TO WHOM IT MAY CONCERN

ME & VT WASTE
MANAGEMENT BRANCH

dh6002b 1"=900'

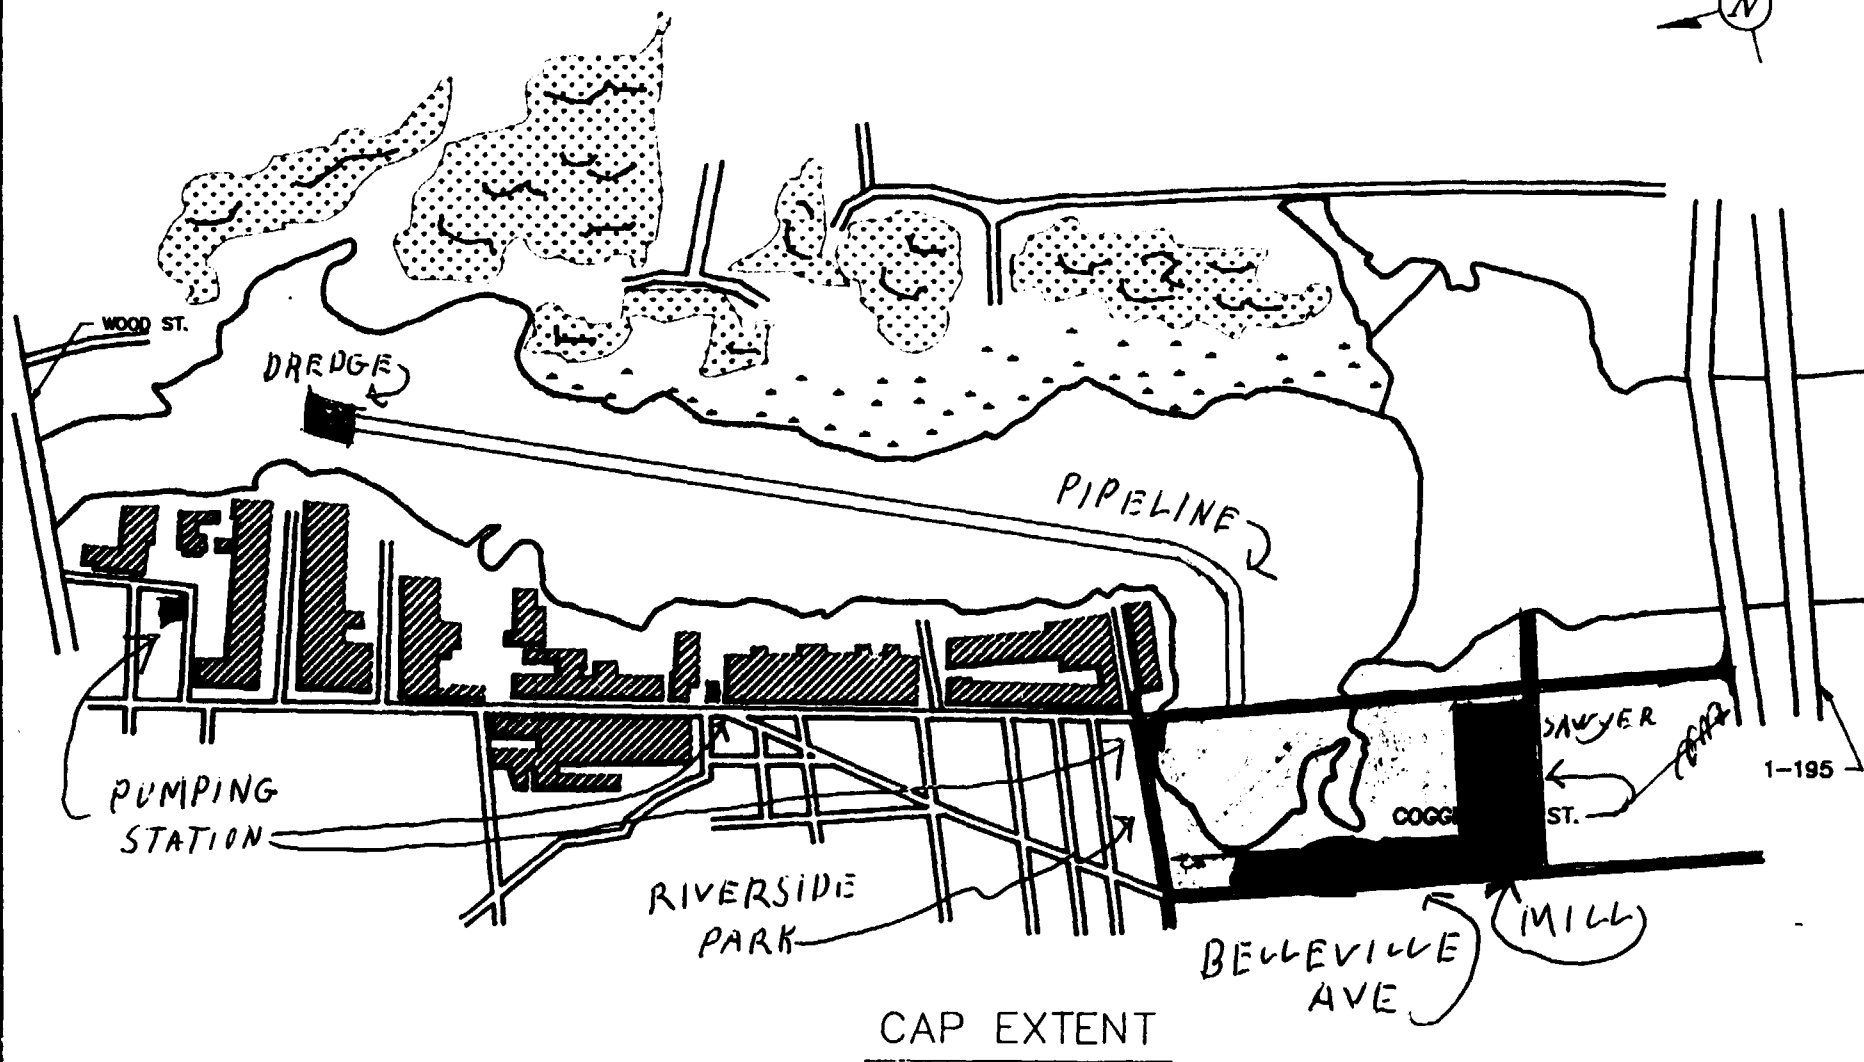
I Manuel Sylvia resident of New Bedford at the foot of Coffin Avenue along the Acushnet River am very concerned about putting dikes in because I feel that any control of the water flow will make the Acushnet River one big mud flat, from Wood St. bridge to Coggeshall St. bridge therefore the smell of the mud will be so great that we won't be able to stand it in this neighborhood. I feel that the whole project of capping the PCBs in the upper estuary will be controlled by the dikes only. Without the dikes I do not believe that the capping would last. So I am against diking or capping it in its present ares. I do think that if Riverside Avenue was continued across the cove to Coggeshall Street, it would make a good barrier for anything in the cove. Therefore I do think that if the PCBs were pumped or dredged from the upper estuary to the cove near Coffin Ave. and Riverside playground where the depth from street level to the mud flat of the cove would be somewhere in the area of 12 ft. or better. There would be sufficient room to pump all the settiments into it then proceed with the capping and covering it with fill or stone dust. It would save a few million dollars plus we could live with it.
